Item No: C0617 Item 11**Subject:** 3-7 & 13-17 REGENT STREET, 287-309 TRAFALGAR STREET AND 16-20 FISHER STREET, PETERSHAM**File Ref:** DA201600286/69462.17**Prepared By:** Jamie Erken - Team Leader Planning Services**Authorised By:** Simon Manoski - Group Manager Strategic Planning**SUMMARY**

On 10 June 2016, Council received a planning proposal relating to three sites that include the properties known as 3-7 Regent Street (Site 1); 13-17 Regent Street (Site 2); and 287-309 Trafalgar Street & 16-20 Fisher Street (Site 3), Petersham.

Image 5: Amended building envelope for Site 2 (13-17 Regent Street)

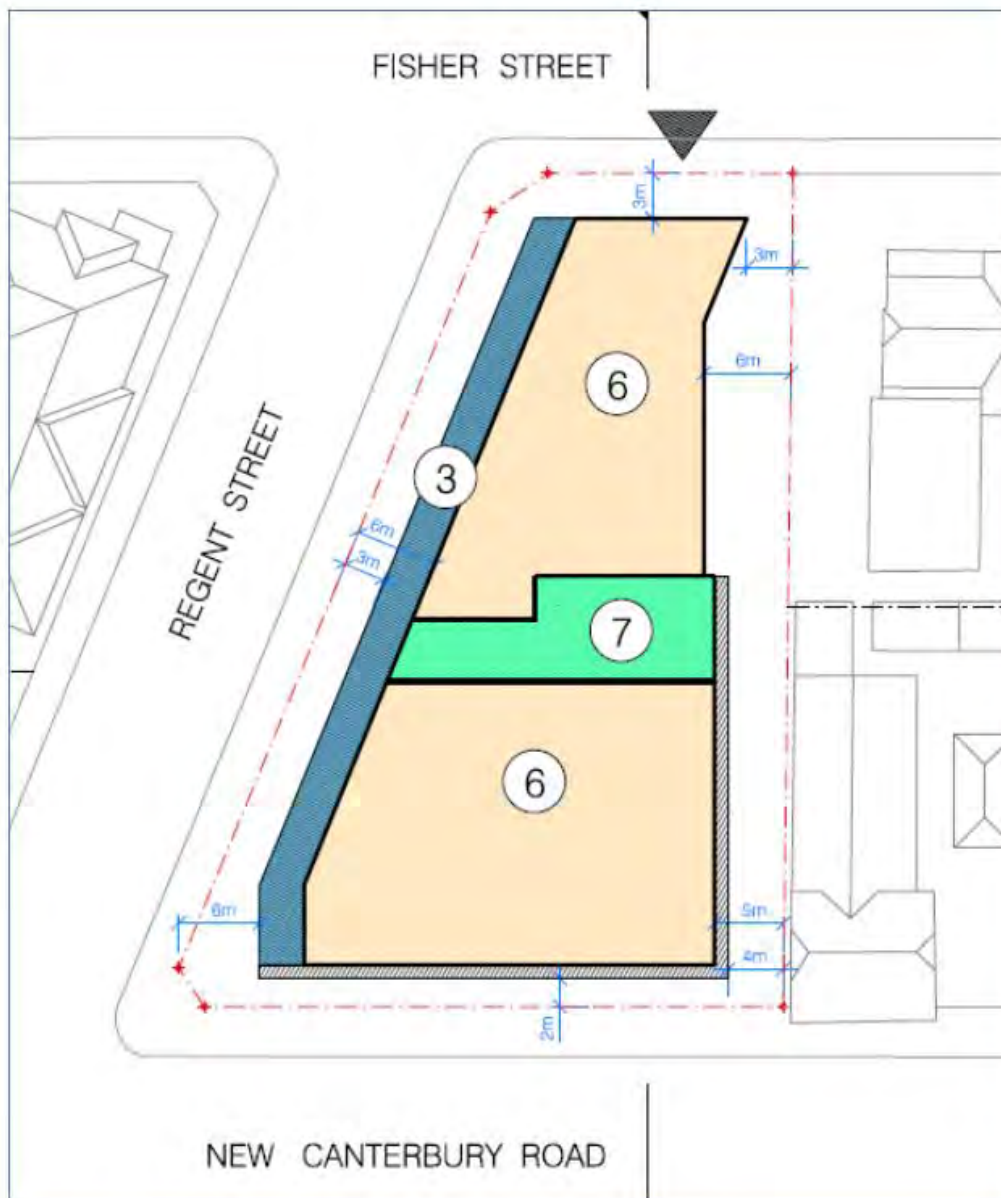
The applicant submitted an amended building envelope for Site 2 that sought to increase the height of the building in line with the comments provided by Council's AEP (i.e. a 6 part 7 storey envelope. The proponent also amended the building envelope to provide a minimum 3 metre setback (with a 1 metre articulation zone) from the New Canterbury Road frontage to provide improved residential amenity for the dwellings.

The applicant's comments regarding the need to remove the trees adjacent to the southern (New Canterbury Road) boundary are supported and it is noted that the building envelope proposed for Site 2 will not result in any greater loss of vegetation than the existing building envelope identified in Part 9.6 of MDCP 2011.

In amending the building envelope for Site 2 the proponent now also proposes a minimum 3 metre setback from the New Canterbury Road frontage (no setback was previously proposed) and this setback will provide enhanced residential amenity and improved streetscape appearance with new perimeter planting to replace the vegetation to be removed.

Image 9: Public Domain Improvement Plan

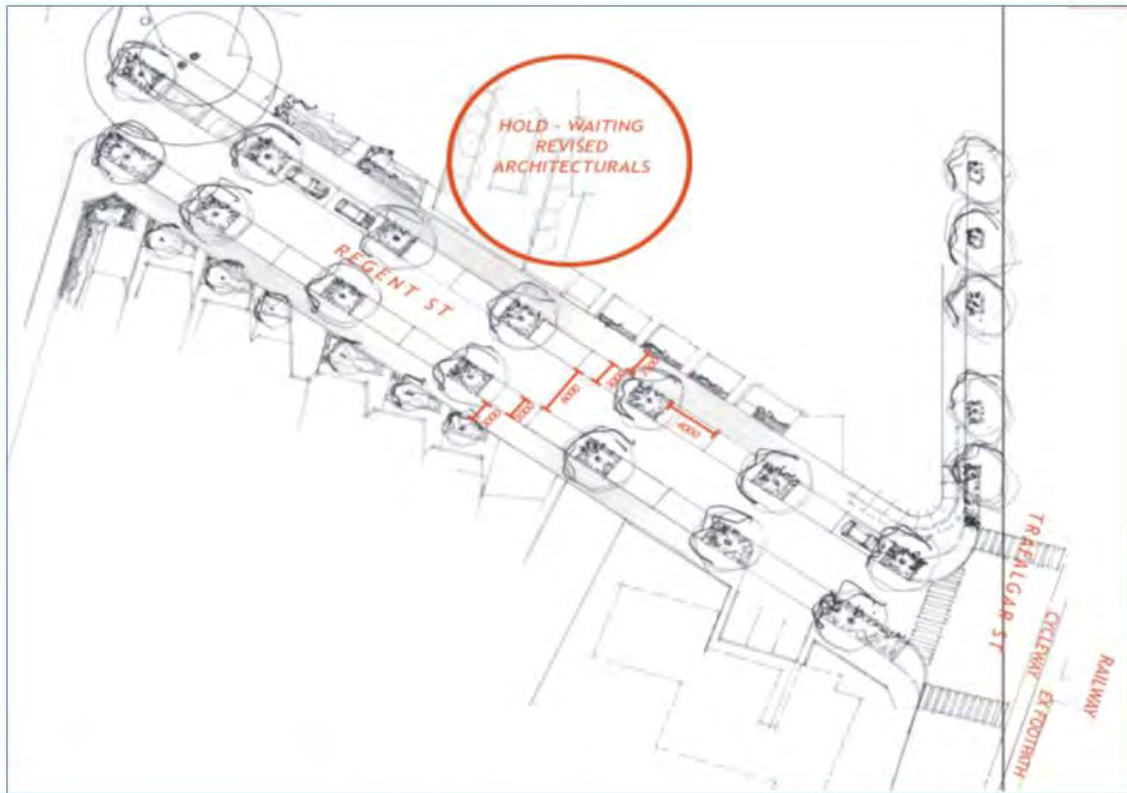
- Kerb blisters with rain gardens and associated planting are to be included at the intersection of Fisher and Regent Street and rain gardens are required along Trafalgar Street.

sketch design prepared by Taylor Brammer Landscape Architects Pty Ltd to demonstrate the typical design of kerb blisters, rain gardens and footpath/road plantings:

The proponent's response to the trees, landscape and street improvement comments provided by Council are generally supported. The building envelopes proposed as part of the subject planning proposal will not result in any greater loss of vegetation than the existing building envelopes identified in Part 9.6 of MDCP 2011.

Notwithstanding, as pointed out above, the proponent has made amendments to the buildings and structures on Site 3 that should allow the retention of the significant trees located on the corner of Regent Street and Fisher Street. Notwithstanding, the proponent has failed to provide evidence (i.e. arborist report) to demonstrate that these trees will be retained. Accordingly, it is a recommendation of this report that should the planning proposal progress to Gateway determination that a condition of the Gateway require the proponent to engage an arborist to investigate the opportunities for the retention of the significant trees located on this corner and adjust the building envelopes as required and that this be provided to Council and made available as part of the public exhibition period.
